# Forensic Investigation of Courthouse Square

555 Court Street NE  
Salem, Oregon

May 2, 2011

Project No. 103-93451.100

*DRAFT*

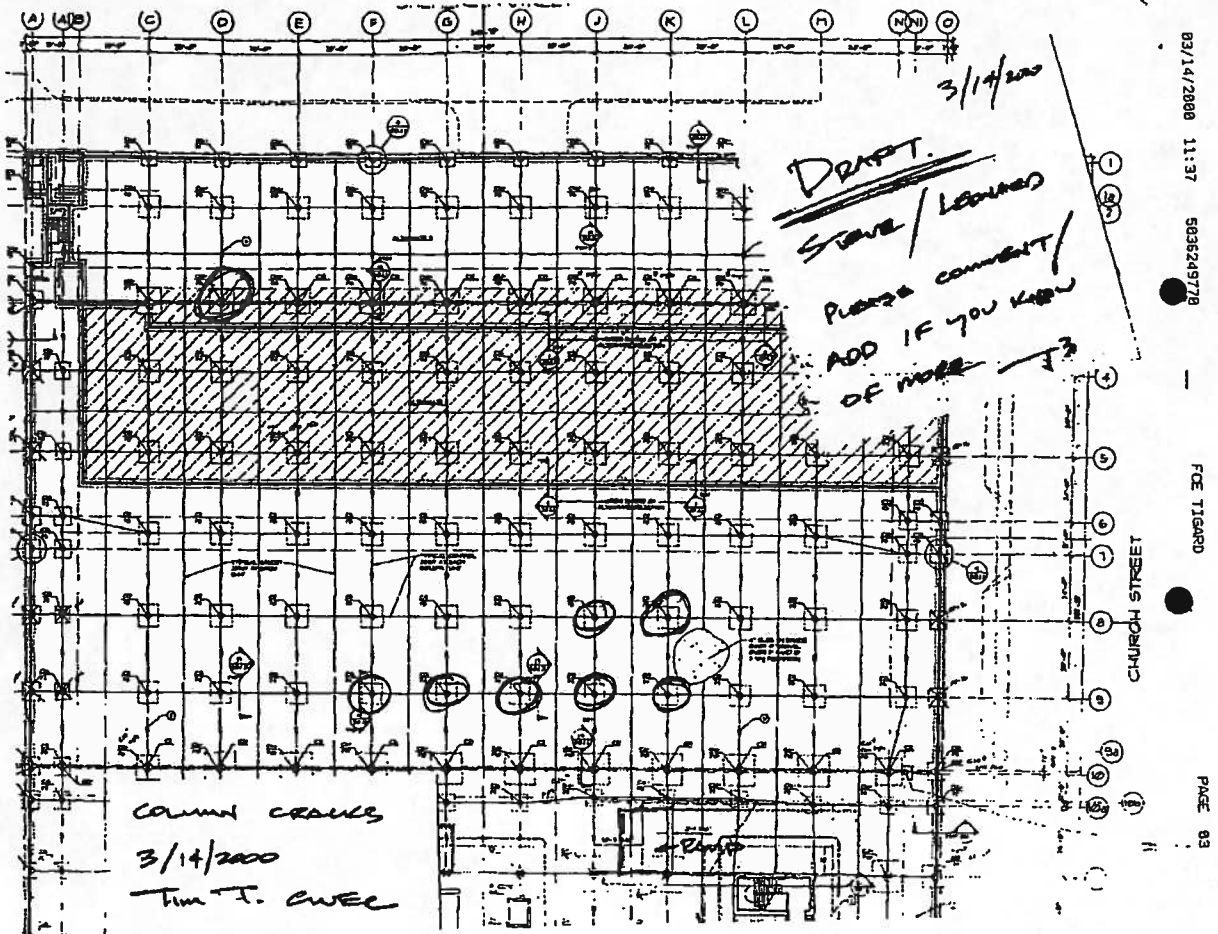
Attached is a map of the columns in the busmall slab that have sustained cracking at the top of the columns. I have circled columns that show cracking based on my observations over the past two months.

<u>Location</u>	<u>Description</u>	<u>Anticipated action</u>
Column 9-F	minor cracking (less than 1/16")	epoxy inject
Column 9-G	minor cracking (less than 1/16")	epoxy inject
Column 9-H	minor cracking (less than 1/16")	epoxy inject
Column 9-J	1/8" cracking at top corners, spalled concrete removed by hand 3/7/2000. We recommend removing loose material, patching and epoxy injecting.	
Column 9-K	1/8" cracking at top corners.	epoxy inject
Column 8-J	minor cracking (less than 1/16")	epoxy inject
Column 8-K	minor cracking (less than 1/16")	epoxy inject
Column 3a-D	1/8" cracking at top corners, some spalled concrete removed by hand 3/7/2000. We recommend removing loose material, patching and epoxy injecting.

**Figure 1 – Office - Grid K with full live loads**

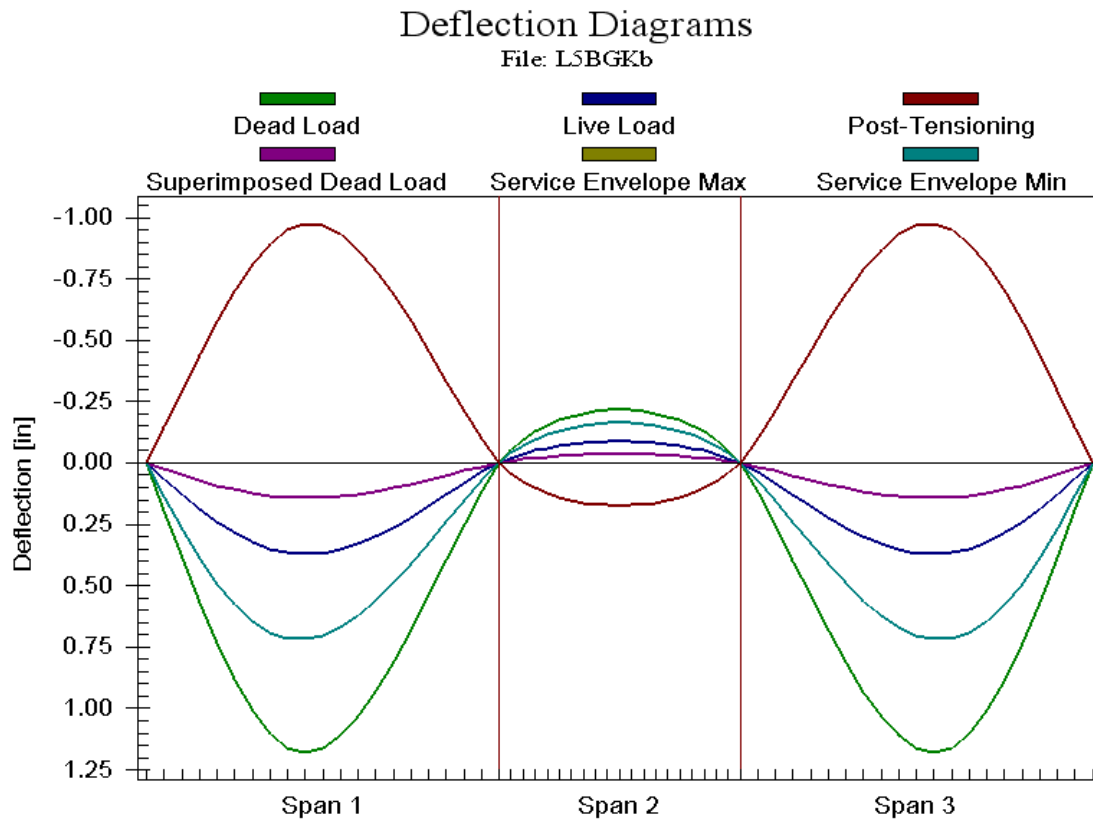
Figure 1 below shows a typical deflection pattern for the transverse (north-south) direction. The exaggerated effects of the two end spans can be clearly seen by reviewing the Service Envelope Min pattern. Figure 2 shows the crowning experienced by the slabs in the longitudinal (east-west) direction due to post-tensioning forces.

This ADAPT analysis, however, does not account fully for the measured movement in the slabs. Deflections calculated by the program vary between 1.25" in the transverse direction and -0.7" in the longitudinal direction, including the long term deflection increase of 100%. This is roughly half the measured deflections in the office building which, depending on the datum selected, are often as high as -1.5" in the longitudinal direction and 2.5" in the transverse direction.

**Figure 3 – Bus Mall - Grid L with reduced live loads**

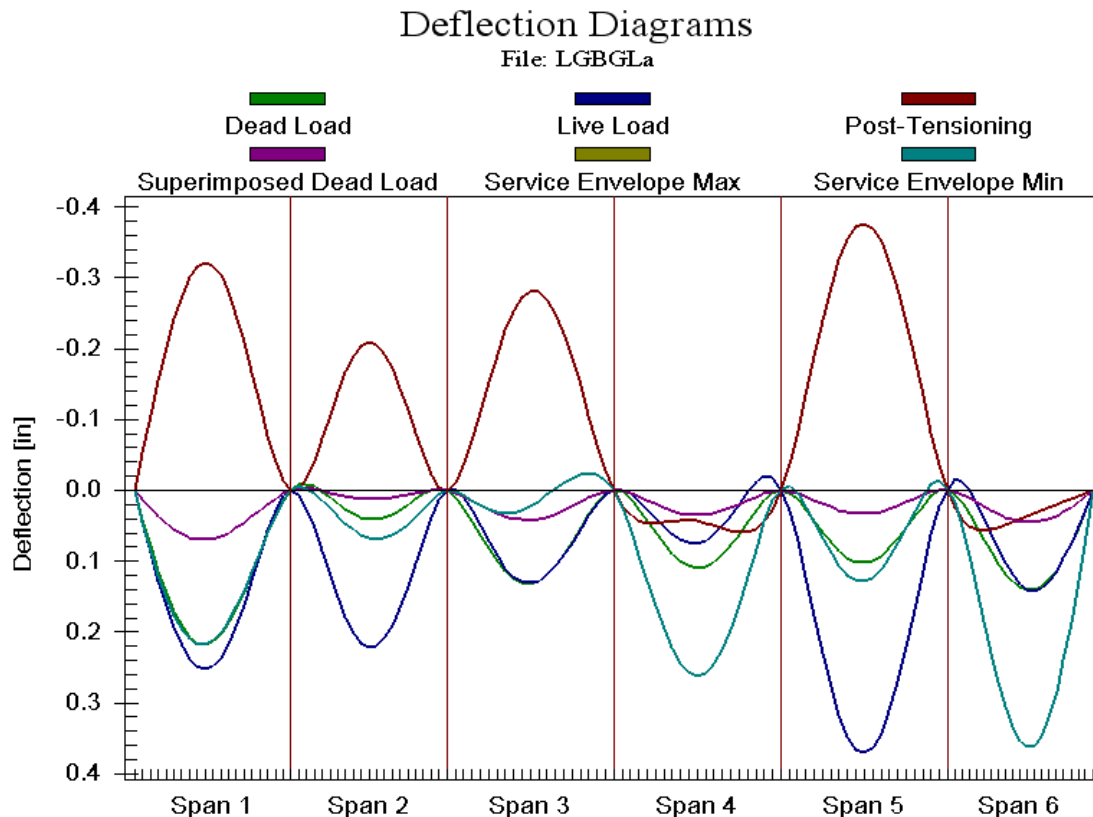
Figure 3 shows the initial deflections due to various loads for grid L at the Bus Mall Level. (Please see the discussion regarding interpretation of these diagrams under Office Building Slabs section above.) At the Bus Mall level, deflections generally are not an issue. Of more concern are the tensile stress levels, both top and bottom, and the shortening of the slab due to both elastic shortening and creep.

For post-tensioned slabs this large it is customary and desirable to provide slip joints to reduce cracking due to compression shortening and creep. A detail for a slip joint between walls and the slab was provided. The location of these joints appeared to be in the corners of the slab edge with the exception of the north wall, where no slip joints could be located using the drawings. While this pattern of joints may be adequate for slabs with moderate compressive stress, it does not appear sufficient to
